ITEM FOR ENVIRONMENTAL COMMISSION AGENDA

NAME & NUMBER OF PROJECT: Omni Business Park, SP-2019-0300C

REQUEST: Variance request is as follows:
Request to vary from 1993 Comprehensive Watershed Ordinance, Section 13-7-16(b) – for a cut exceeding four feet

Staff Findings of Fact and Exhibits

Cut Fill Exhibit

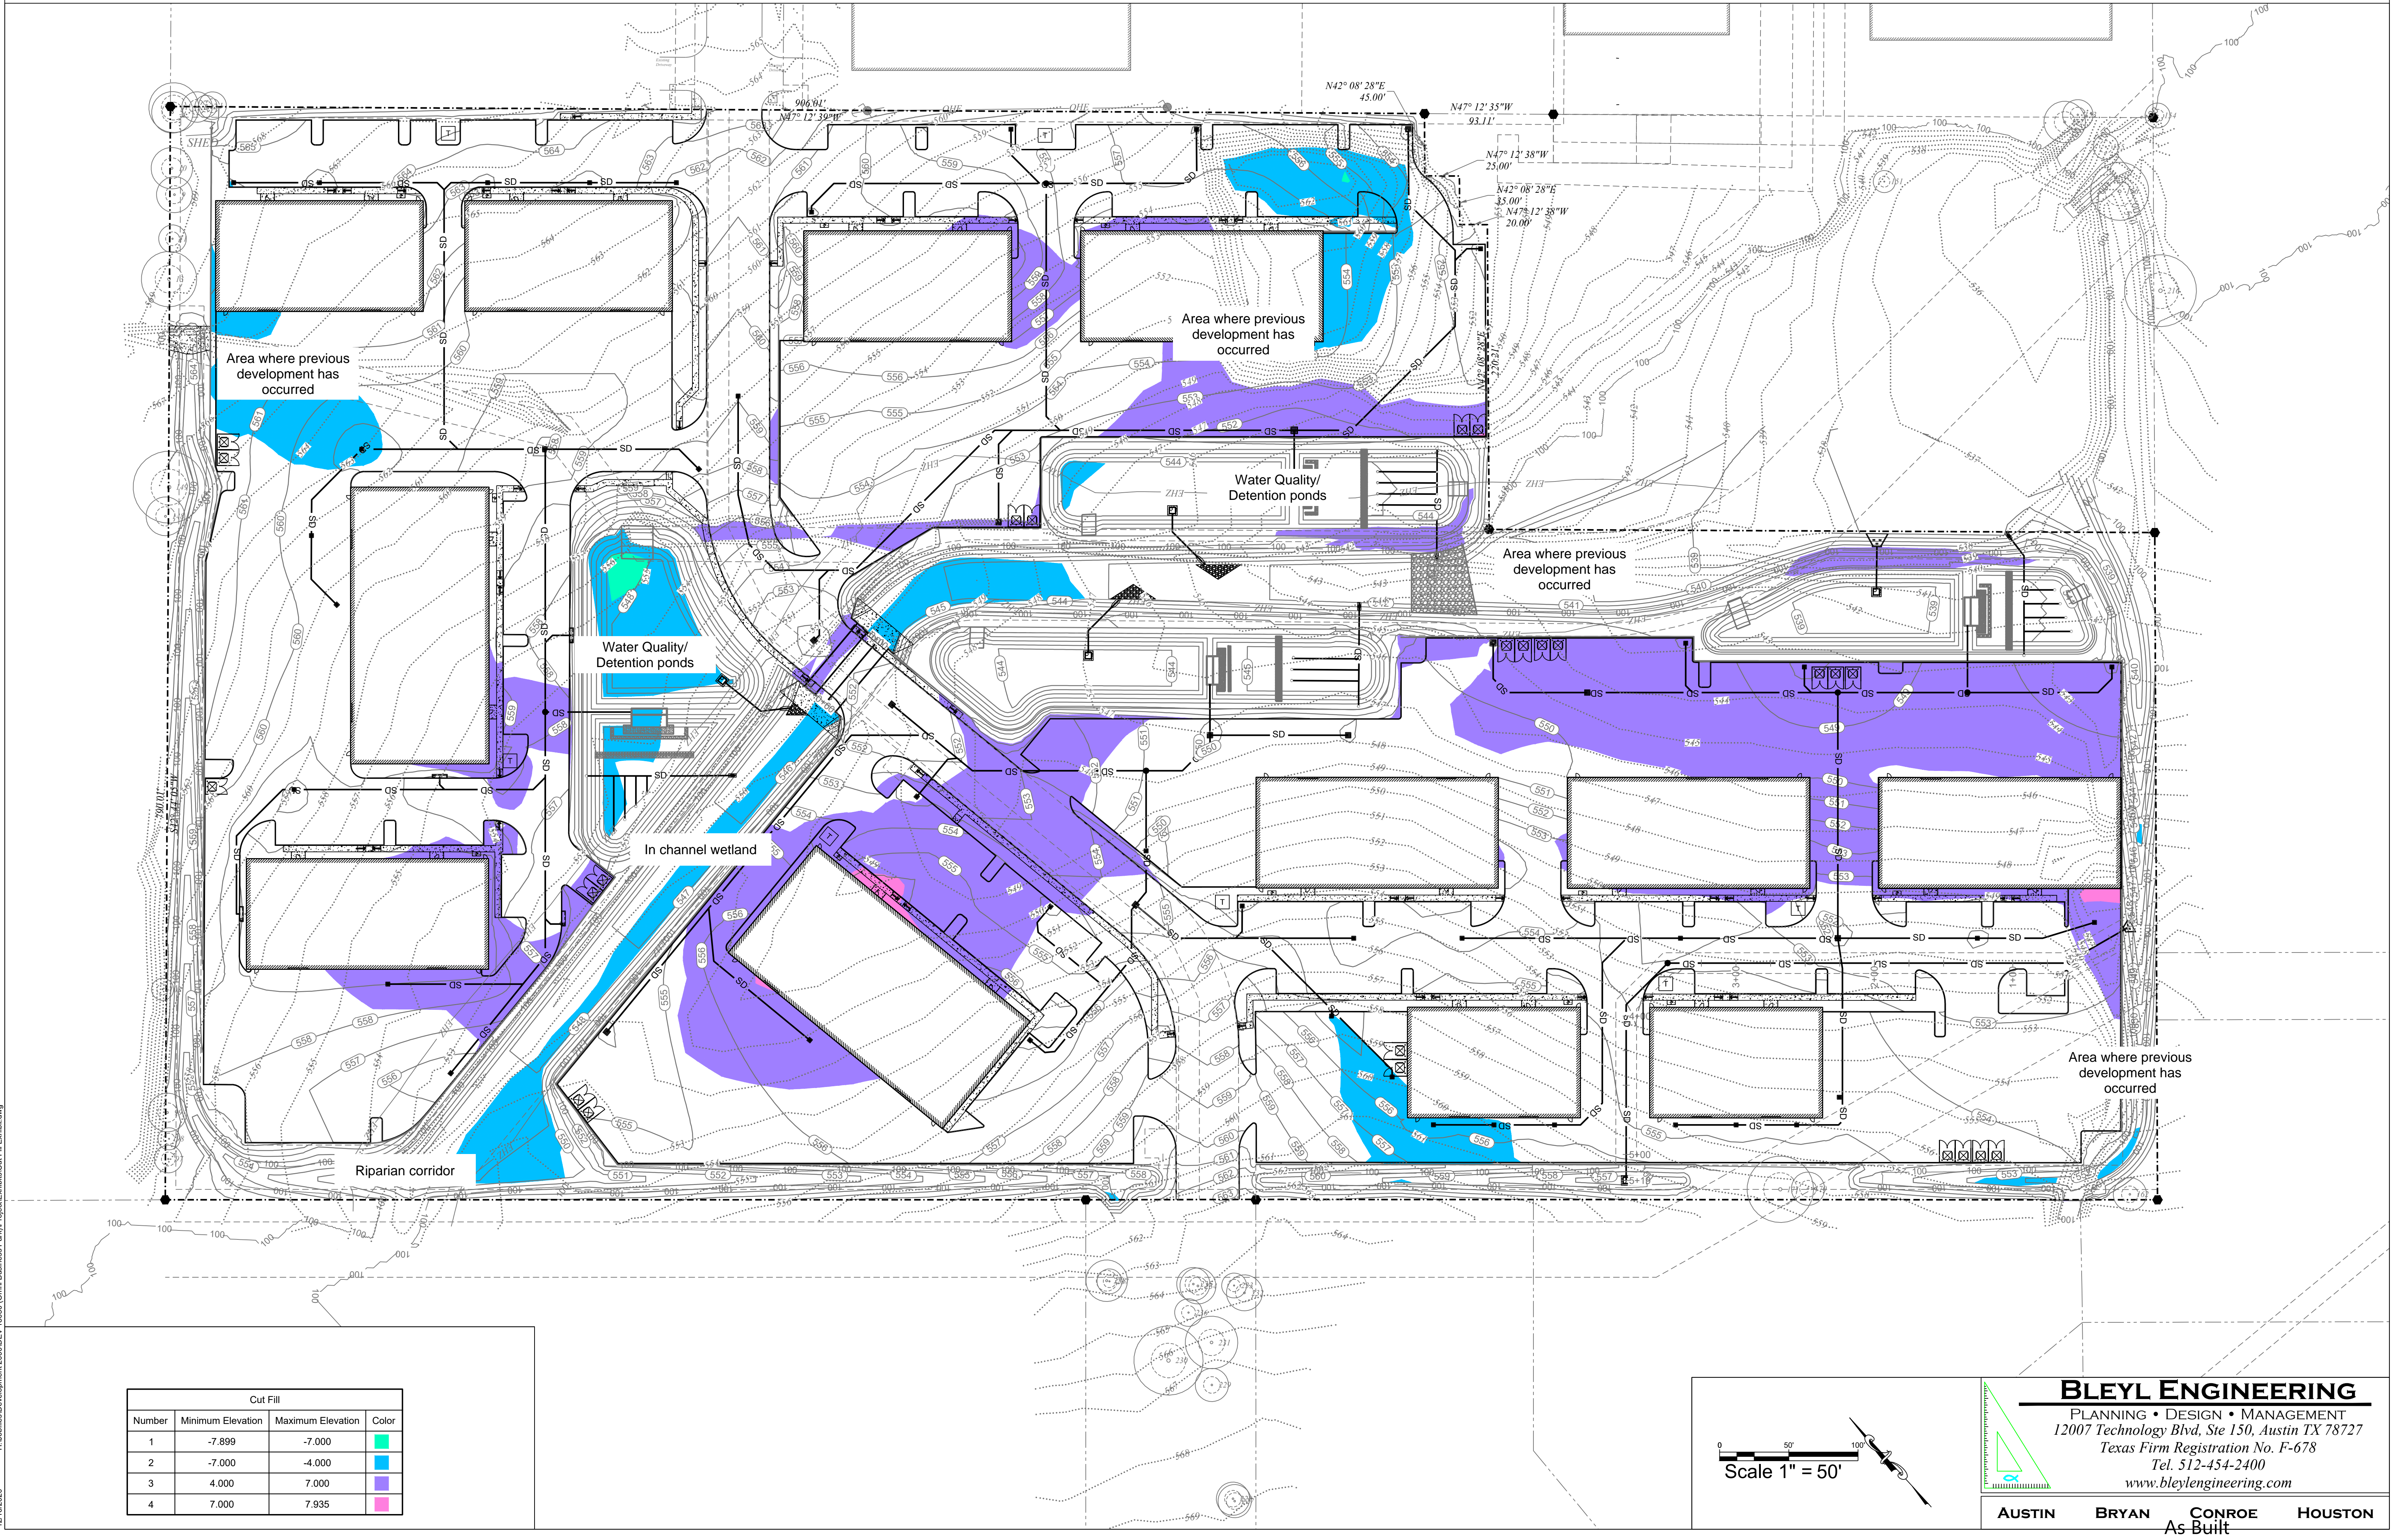
Yes Development has occurred on this site, specifically drainage improvements. Areas of cut exceeding four feet are to level the grading

associated from previous development, including multiple spoils piles. Additionally, this property is zoned limited industrial and the project proposes construction of warehouses with truck loading docks. Cut exceeding four feet for this type of development with its existing conditions is required, similar to the surrounding commercial and industrial development (e.g, Burleson Industrial Park – SP-2014-0400C; 7005 Burleson Industrial – SP-2015-0353C; Burleson Warehouse – SP-2017-0356C) where cut greater than four feet have been permitted. Moreover, the proposed cut will not exceed eight feet which, under current code, would have been administratively approved. Granting this variance would allow the property owner the privileges enjoyed by other property owners and facilitate a reasonable use of the property.

Yes The cut limits of the site will not exceed eight feet. Previous construction activities have occurred onsite, including multiple spoils piles. As a result, cut exceeding four feet is necessary to level out these areas. Also, cut is required for the proposed multiple riparian corridors and in-channel wetland. Additionally, for the water quality ponds, cut of a maximum of eight feet is essential to adequately treat the pollutant load of the development. Further, an enhanced landscape planting schedule with native and diverse vegetation and seeding are proposed for the pond berms, riparian corridors, and in-channel wetland. For these reasons, the variance request to exceed the four feet cut limit will not create significant probabilities of harmful environmental consequences.

- 1) Preserve top 12 inches of topsoil to be used onsite;
- 2) Increased landscaping for areas of fill to stabilize erosion; and
- 3) Provide enhanced erosion & sedimentation controls during construction.

- 1) Preserve top 12 inches of topsoil to be used onsite;
- 2) Increased landscaping for areas of fill to stabilize erosion; and
- 3) Provide enhanced erosion & sedimentation controls during construction.
